Corrective Action Decision Document/ Corrective Action Plan (CADD/CAP) for Corrective Action Unit (CAU) 443: Central Nevada Test Area (CNTA)– Subsurface Central Nevada Test Area, Nevada, DOE/NV–977

January 2008

**Comments from NDEP and DOE responses**

RE: Addendum to: Corrective Action Decision Document/Corrective Action Plan (CADD/CAP) for Corrective Action Unit (CAU) 443: Central Nevada Test Area (CNTA) — Subsurface Central Nevada Test Area, Nevada, DOE/NV-977, November 2007 Federal Facility Agreement and Consent Order

Figure 7. Proposed locations of the two new alluvial wells to be drilled in 2008 and five seismic lines acquired in October 2007.

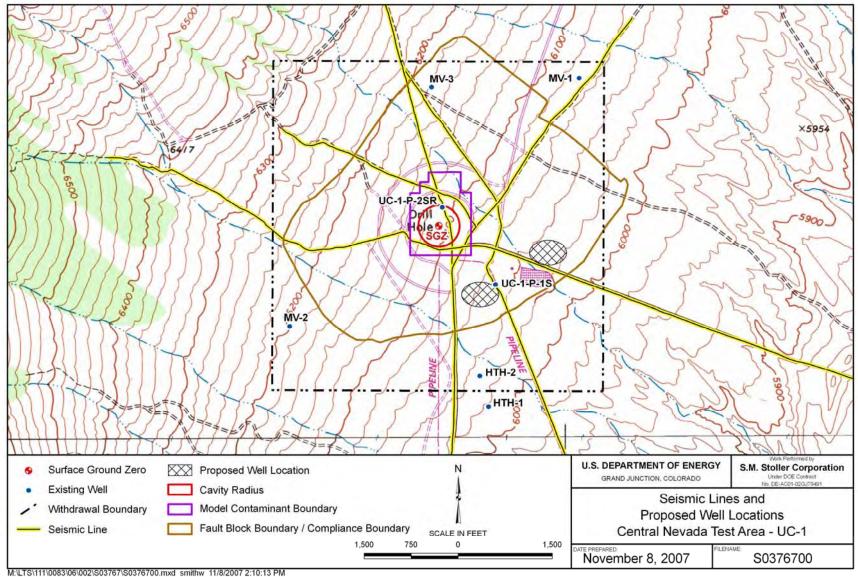
- The NDEP looks forward to receiving the report detailing the results of the five seismic reflection profiles acquired in October 2007 at the CNTA and referred to in Section 5.6.3 of the document.

- 1. Boise State will be providing a draft report of the seismic survey results in late January 2008. Preliminary seismic results appear to confirm the locations of the proposed alluvial wells shown in Figure 7 of the addendum document. The DOE-LM will provide a copy of the final seismic survey report when received.
- 2. The correct reference should be to Table 5-1 of the CADD/CAP. The change will be made.
- 3. The schedule was developed prior to the letter that requested the extension until January 11, 2008. Thanks to the rapid turnaround of comments from NDEP, the addendum will be final prior to the January 11, 2008 deadline. A new schedule with the revised dates will be included in the final addendum.
- 4. The data presented in Tables D-1 and D-2 were collected on September 6 and 7, 2007. The dates will be added to the table captions.

Figure 8. Project Schedule.

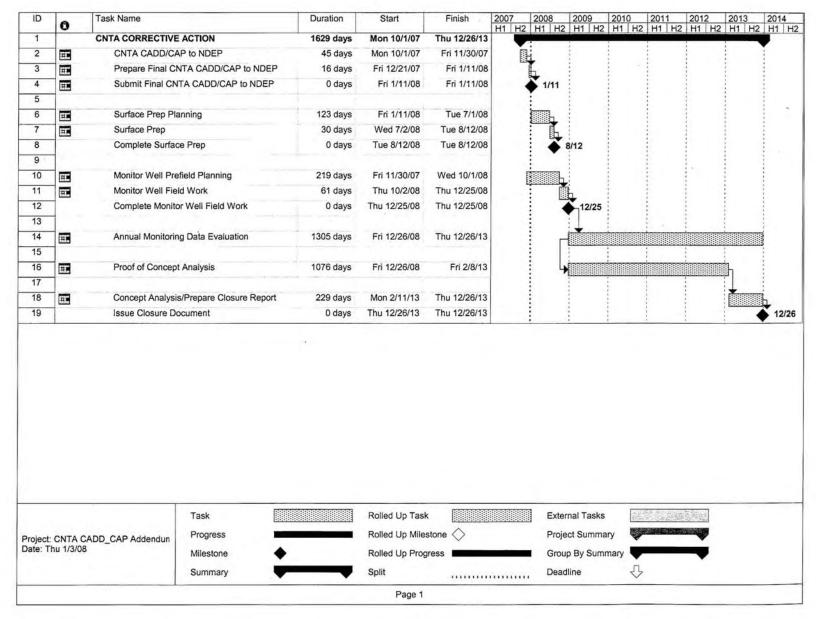
- 3. Figure 8 This Figure lists the date for submittal of the Final CNTA CADD/CAP to NDEP as January 31, 2008. However, a November 9, 2007 letter from the NDEP to Mr. Jack Craig established the Milestone Deadline for Corrective Action Unit 443, Central Nevada Test Area Subsurface <u>Final</u> CADD/CAP Addendum as January 11, 2008. Should the U.S. Department of Energy/Office of Legacy Management require an extension to this Milestone Deadline of January 11, 2008, such a request must be made of the NDEP pursuant to Subpart X.1 of the Federal Facility Agreement and Consent Order (FFACO).
